HARTING Product Termination Notification

PTN/17/004/C+N

Product range: Han / Han High Temp

Title: Phase-out Han High Temp Inserts - External.docx

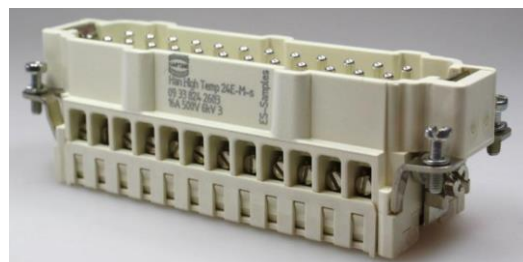
Due to new molding tools we decided to change the inserts of the Han® High Temp portfolio to a new design leading to new part numbers. The technical characteristics have been improved to a working voltage of 500 V.

- Increased working voltage to 500 V
- 100 % mating compatible with old design

09338062604 Han High Temp 6E-crimp male
09338062704 Han High Temp 6E-crimp female
09338062603 Han High Temp 6E-screw male
09338062703 Han High Temp 6E-screw female

09338102604 Han High Temp 10E-crimp male
09338102704 Han High Temp 10E-crimp female
09338102603 Han High Temp 10E-screw male
09338102703 Han High Temp 10E-screw female

09338162604 Han High Temp 16E-crimp male
09338162704 Han High Temp 16E-crimp female
09338162603 Han High Temp 16E-screw male
09338162703 Han High Temp 16E-screw female

09338242604 Han High Temp 24E-crimp male
09338242704 Han High Temp 24E-crimp female
09338242603 Han High Temp 24E-screw male
09338242703 Han High Temp 24E-screw female
